# Truro Board of Health

Tuesday August 1, 2023

**To:** Truro Board of Health  
**From:** Emily Beebe, Health & Conservation Agent  
**Date:** July 29, 2023  
**Re:** August 1 meeting: septic upgrades- review notes

**24 Cliff Road, Blair & Paul Resika (29/13) : Local Upgrade Approval & Local Variance**

**SITE & SEWAGE DISPOSAL SYSTEM PLAN**  
24 Cliff Road, North Truro, MA

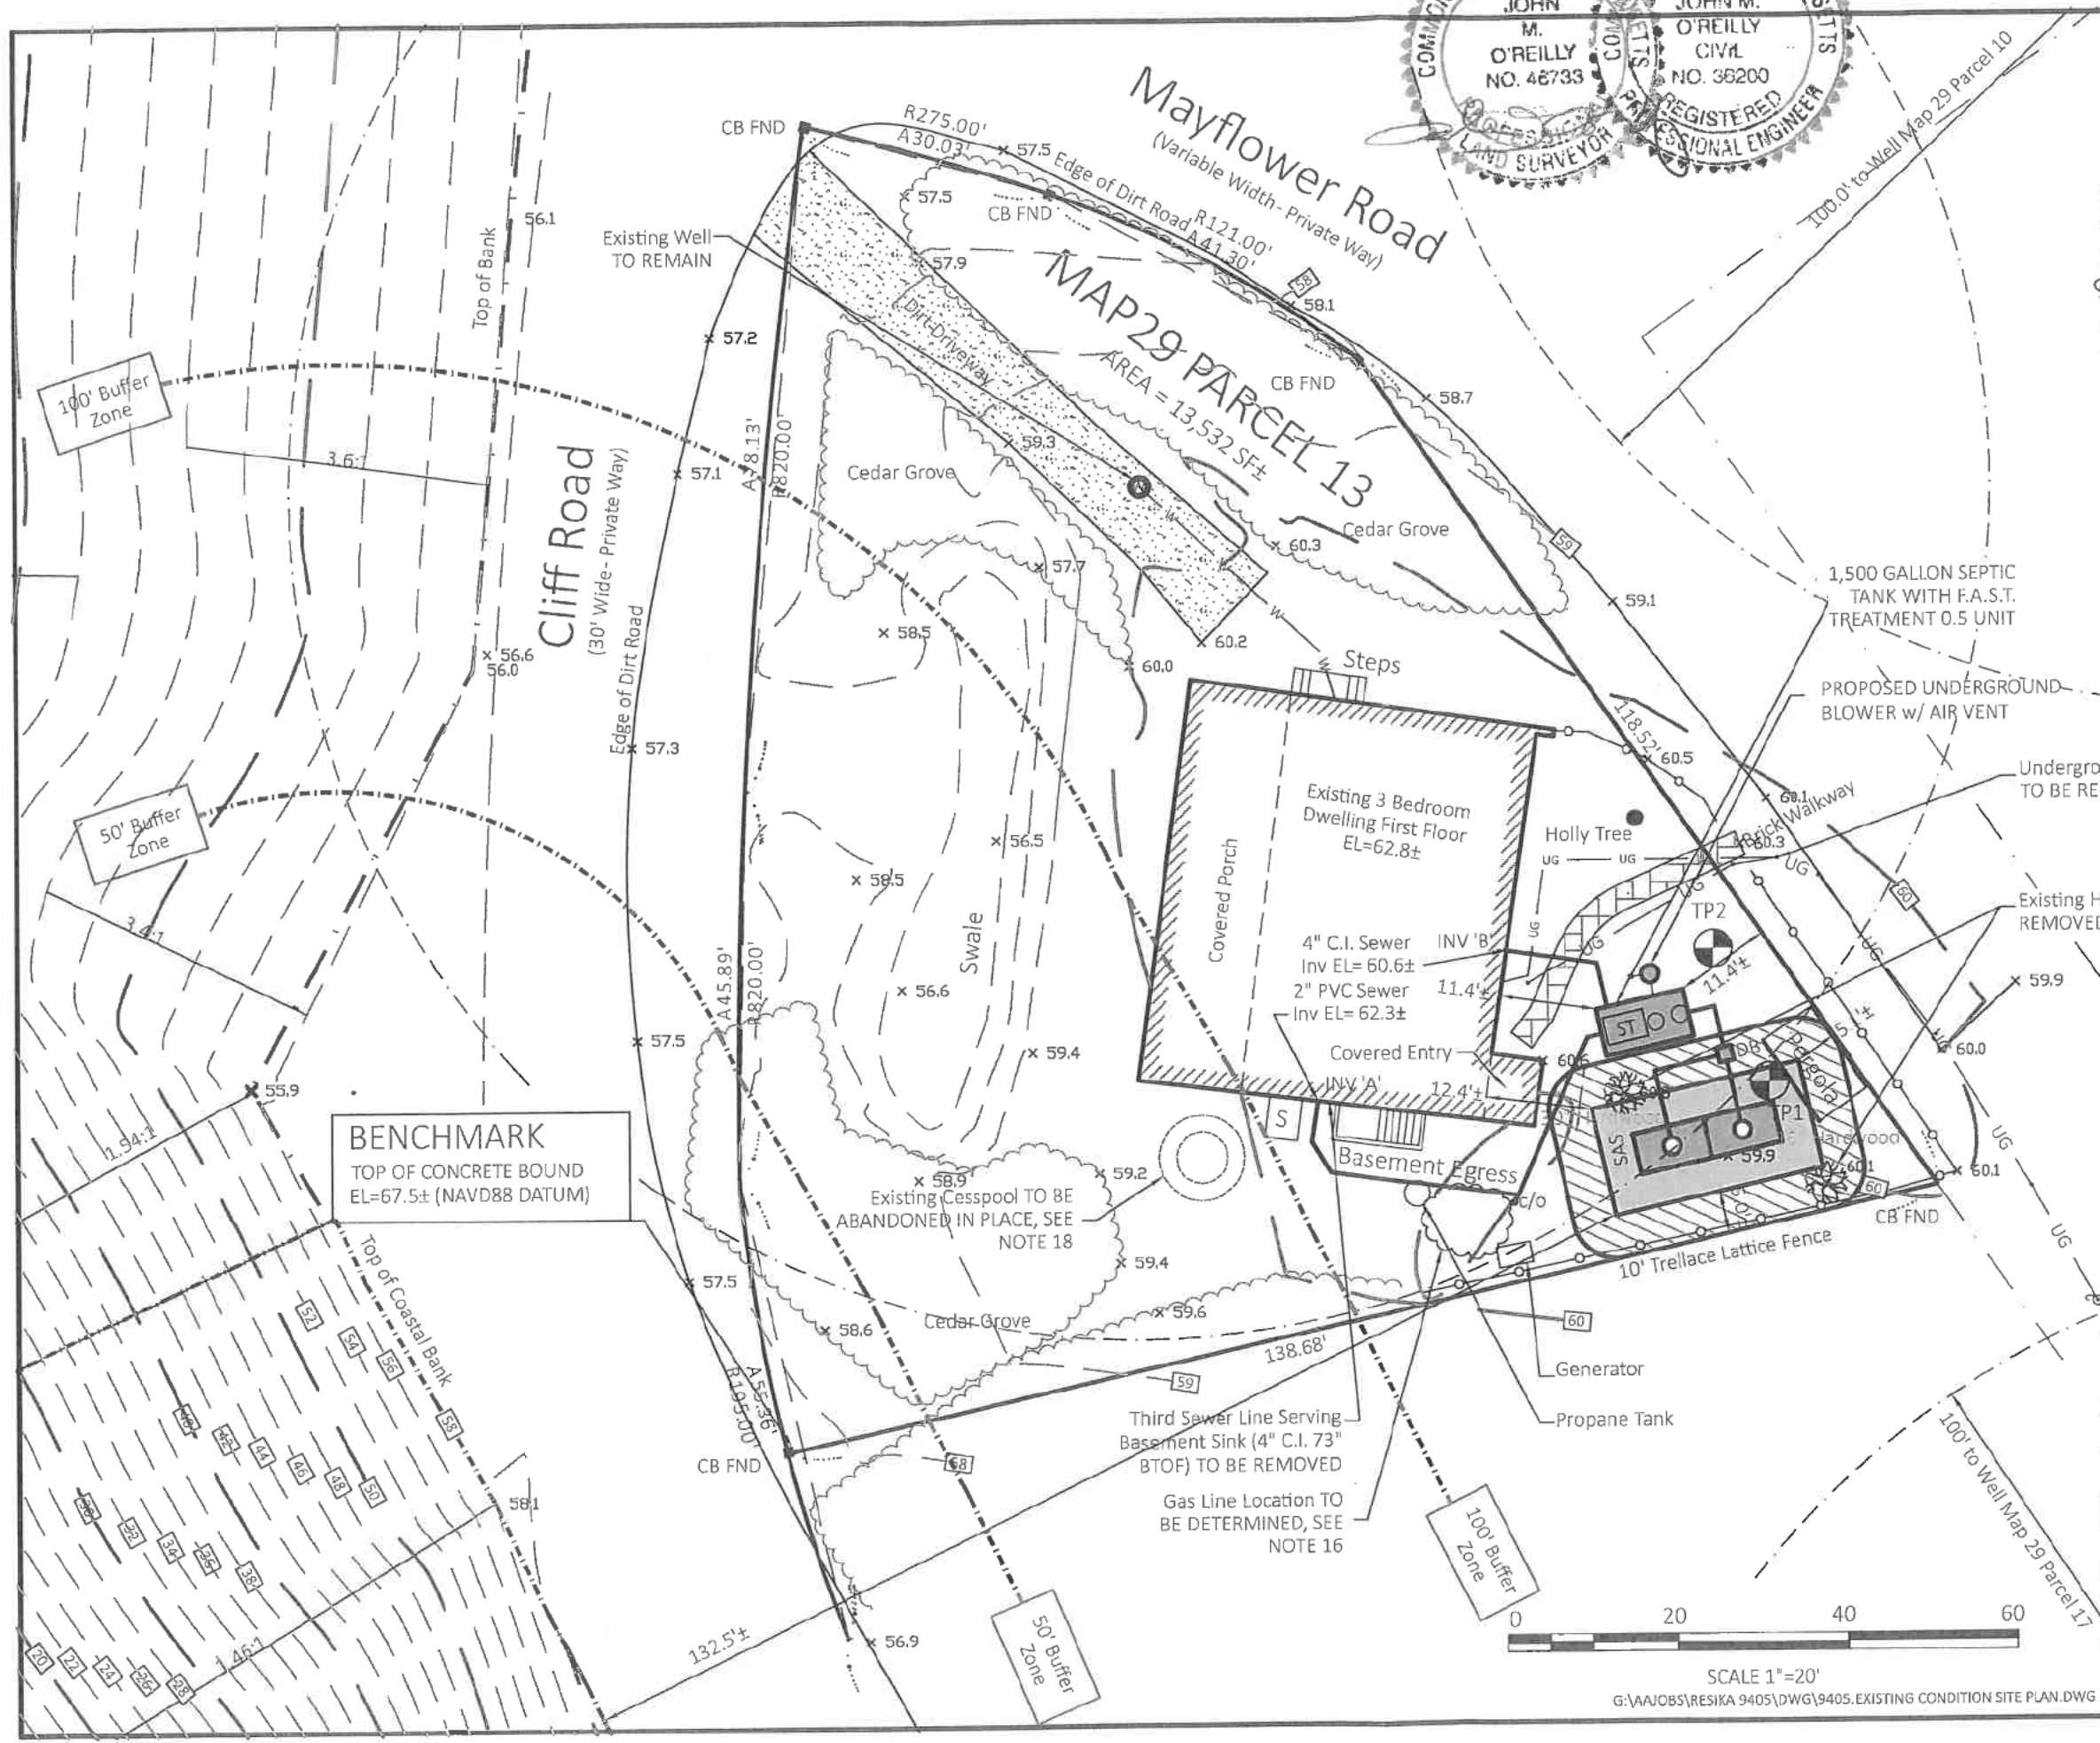
**Request** This upgrade from cesspools will serve an existing 3-Bedroom dwelling on a 13,532 sf parcel on High Head. (the sketch of the floorplan is mis-labeled and a correx will be forthcoming from the engineer for the meeting)

- There is no proposed increase in flow, however, the existing use on this lot size triggers the use of I/A technology. A FAST 0.5 “enhanced treatment unit” is proposed. (This meets BAT\* standards) We expect to have more information about this system at the meeting, including the DEP approval letter.

- Local upgrade variance requests include provision of less than the required separation between the SAS (soil absorption system) and property lines, foundation and the on-site well

- This upgrade appears to be a significant improvement in treatment that will be of benefit to the resource areas.
- No wells in this area appear downstream of the SAS including the locus well.

- Local upgrade approval requests are for provision of less than the required separation between the SAS (soil absorption system) and the adjacent wetland resource area (Coastal Bank)

The Board can approve this proposal after:

- 1) making the determination that the standard of review has been met; and
- 2) consideration of a condition of approval that the owner is provided with information about proper care of an I/A septic system, with an explanation about what the Operation and Maintenance requirements will be throughout the year.

**SITE PLAN**  
1 MILL POND ROAD  
TRURO, MA

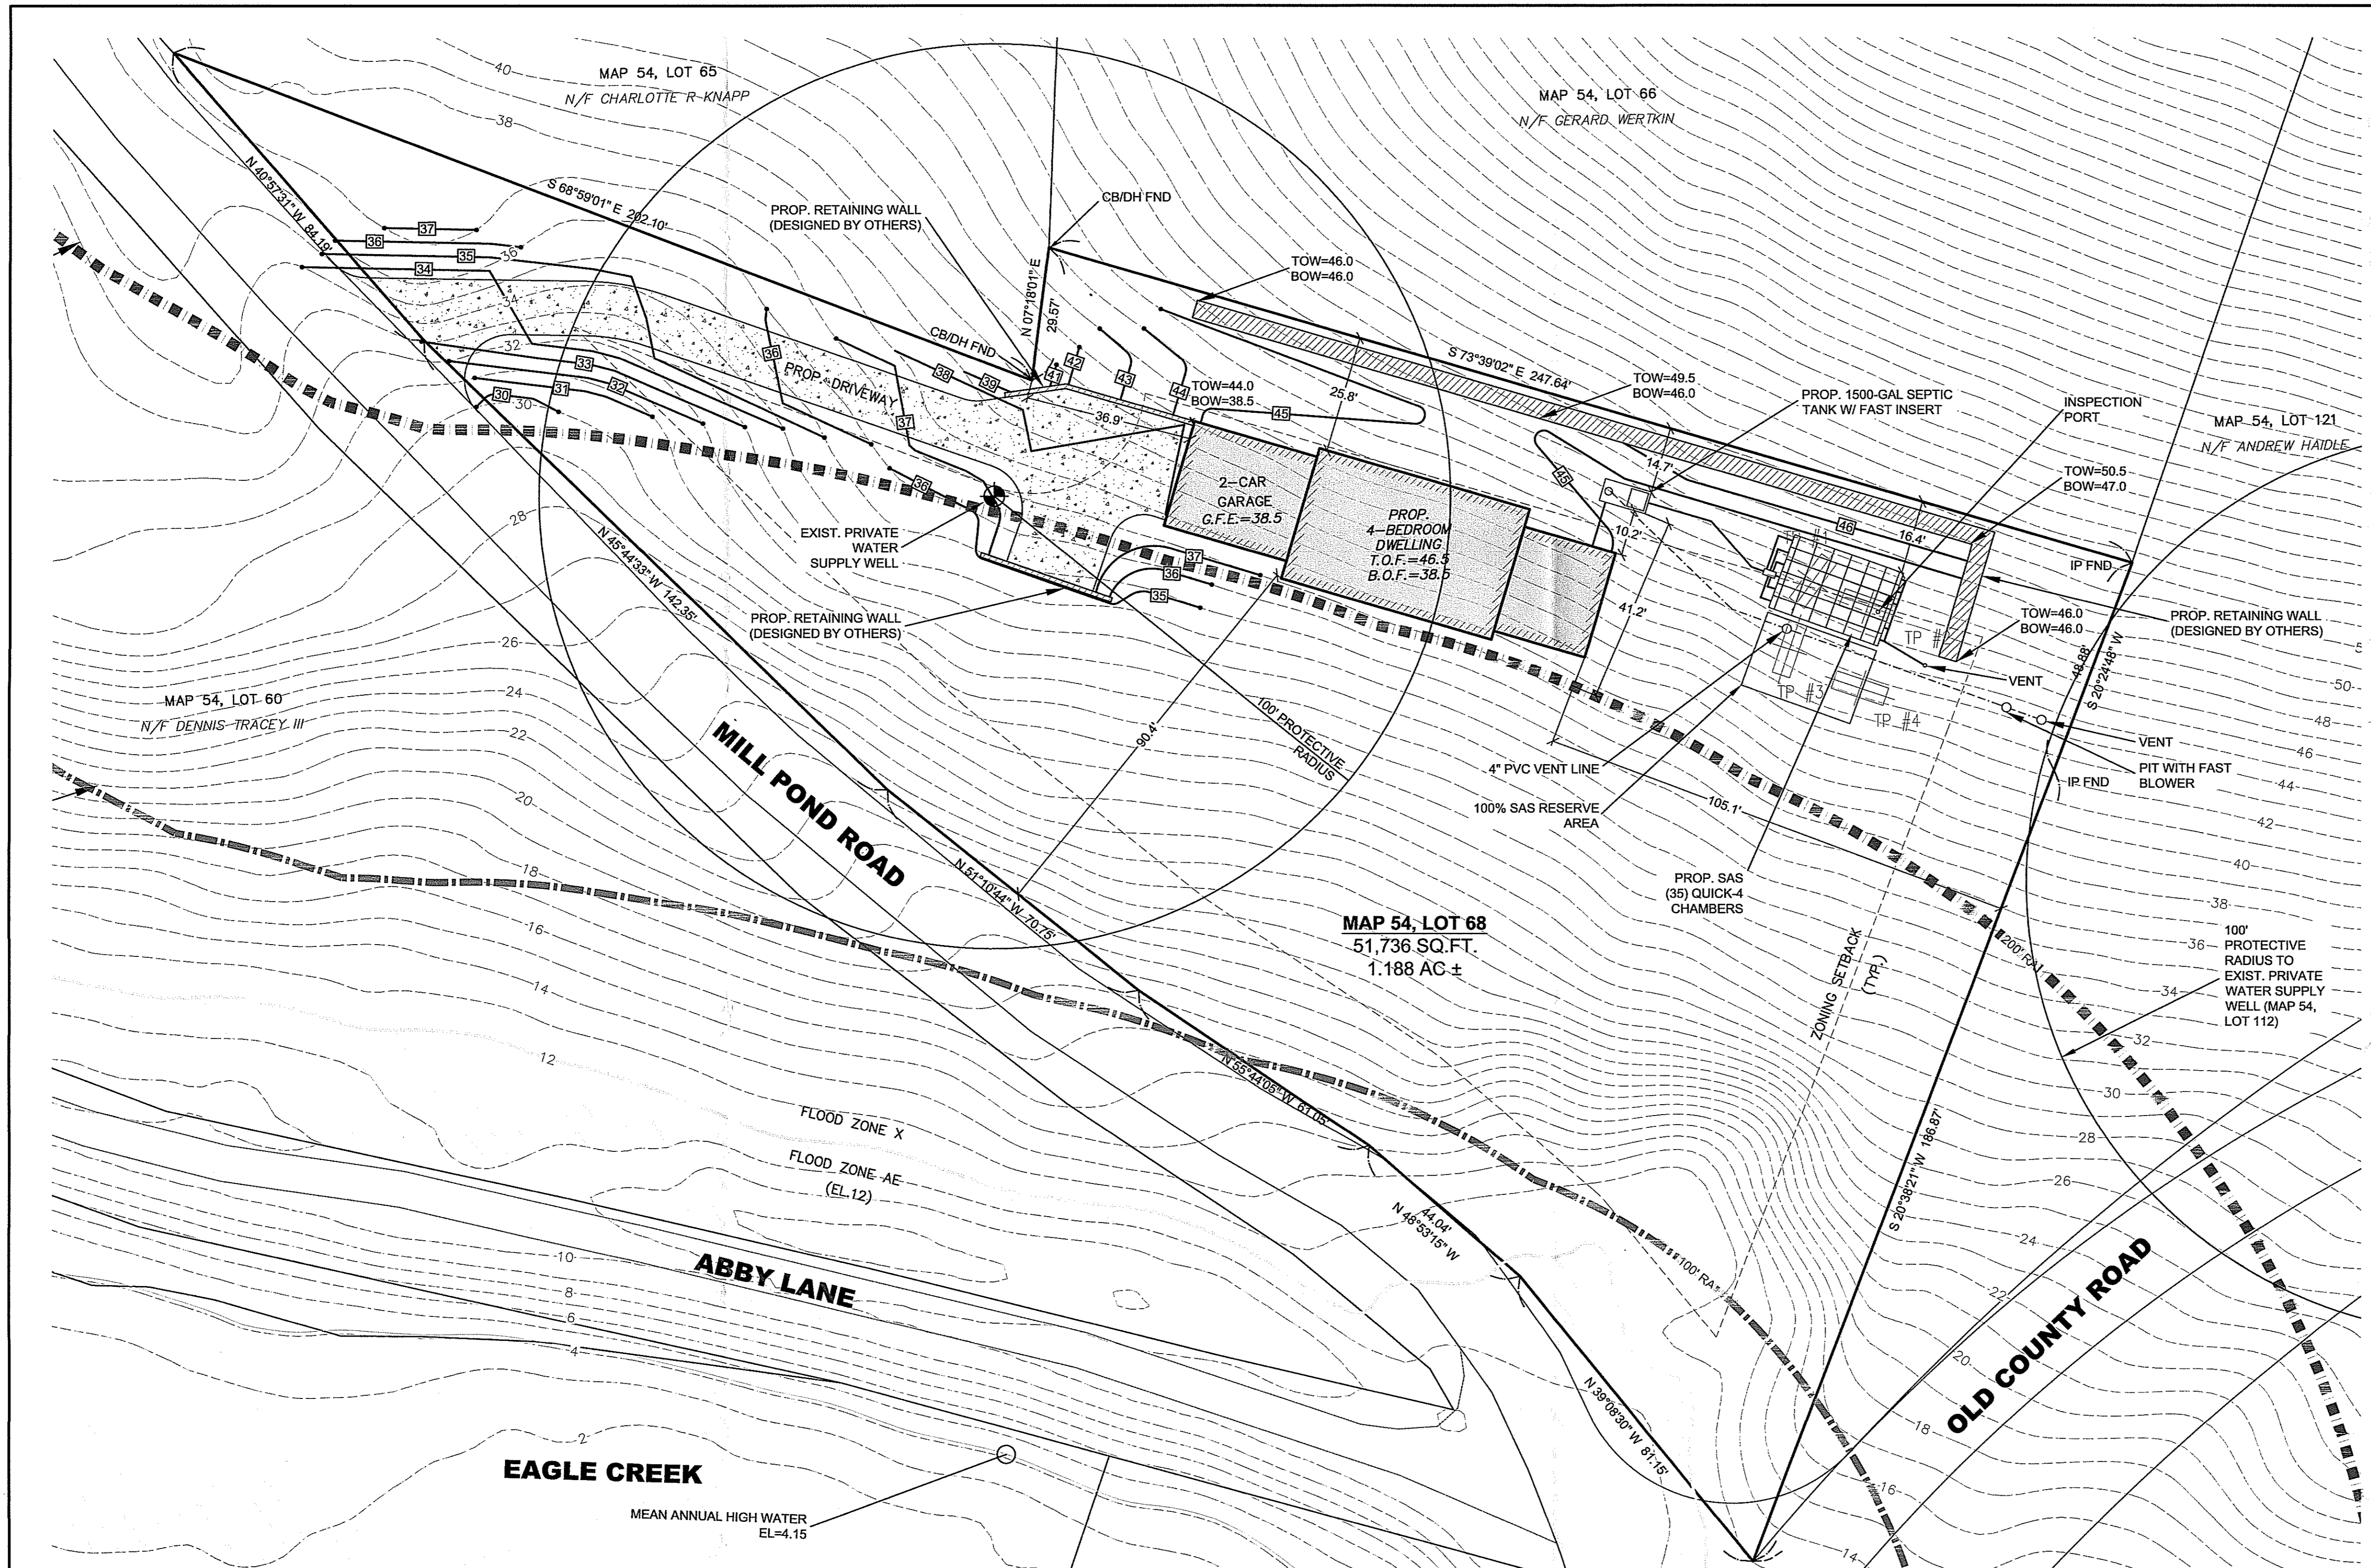
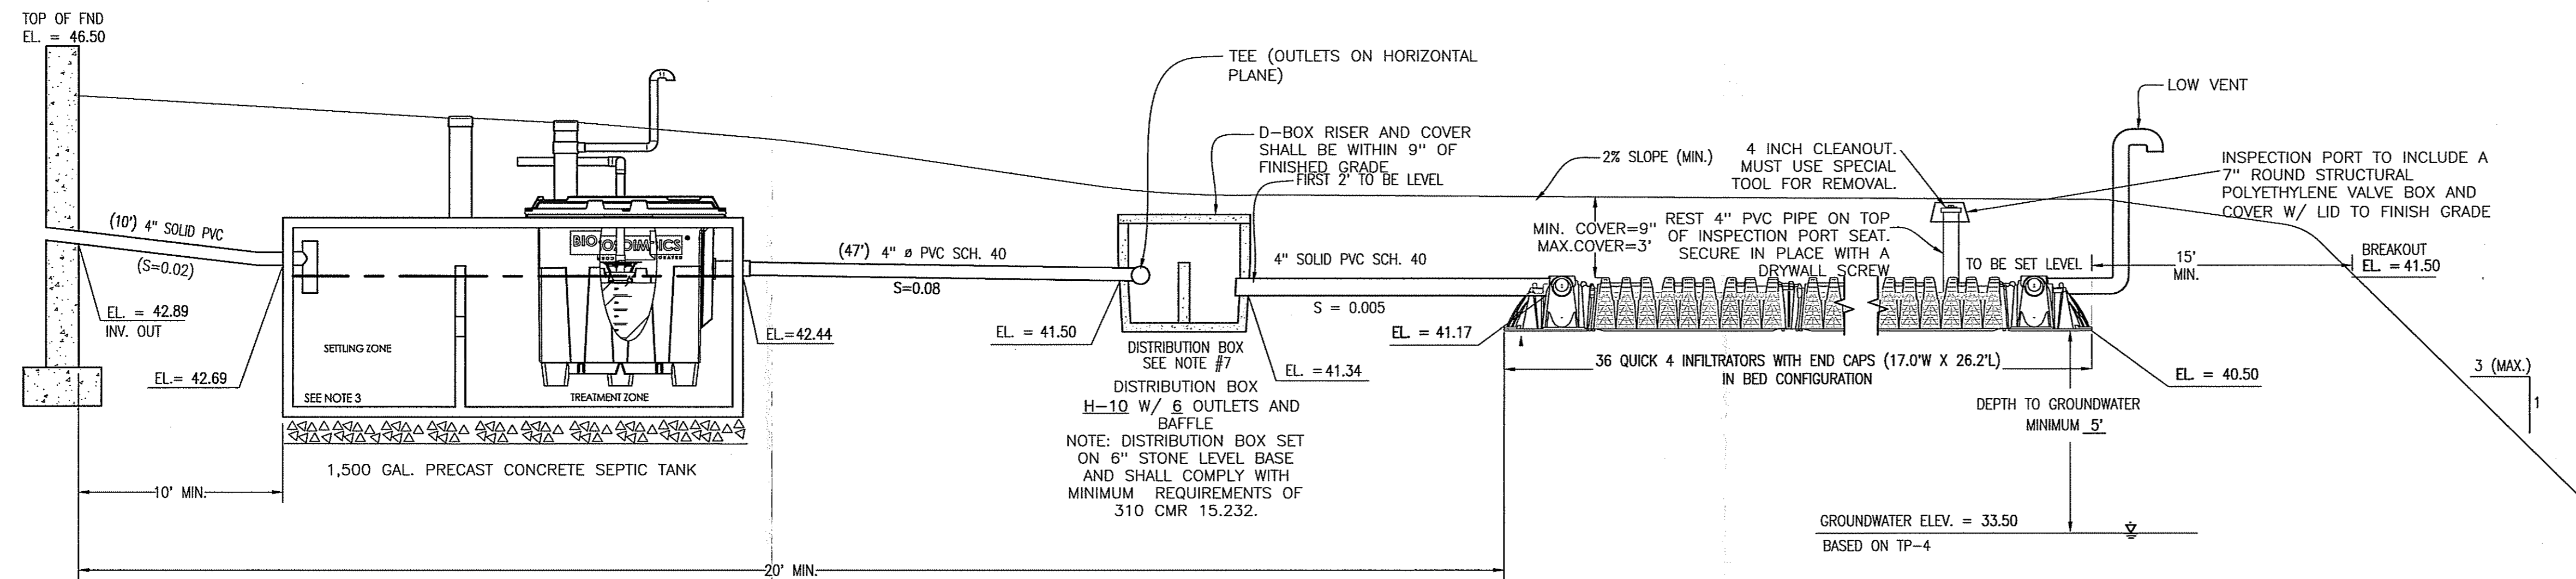
This project proposes construction of a 3-BR (Although the plan shows a 4 BR in at least 1 location!) single-family dwelling on a 51,736 sf parcel adjacent to Mill Pond Road, Old County Road and the Pamet River. The parcel is located within the wetland resource area of Riverfront, reducing the available area of upland to approximately 21,367 sf; this provides enough area for a 2-bedroom home under our Local Board of Health regulations.

- Both title 5 and Truro Board of Health (TBoH) regulations require horizontal separation to wetlands, but they have different definitions of wetlands
  - Title 5 does not include Riverfront as a wetland resource area, however, our TBoH regulations do.
  - The title 5 requirements for horizontal separation between the septic tank and SAS(soil absorption system) to most wetlands are 25' and 50' respectively, while the separation required by our TBOH regulations are 100' and 150'.
- Additionally, Title 5 does not define "upland", but our TBoH regulations do.
- TBoH regulations define upland as area that is exclusive as all jurisdictional (WPA) wetland resource areas. Further, only upland may be used in the calculation of lot area available for nitrogen loading.

The plan before you depicts an undeveloped parcel with new construction proposed. The SAS cannot be sited on the lot in compliance with the local setbacks for wetlands.

- The standard of review for the Board of Health is to determine if the design showing reductions to the requirements of local regulations will provide as much environmental and public health protection as would a plan without variances. A determination (such as a statement of finding) or a motion should be made to declare whether the proposed project meets this standard of review.
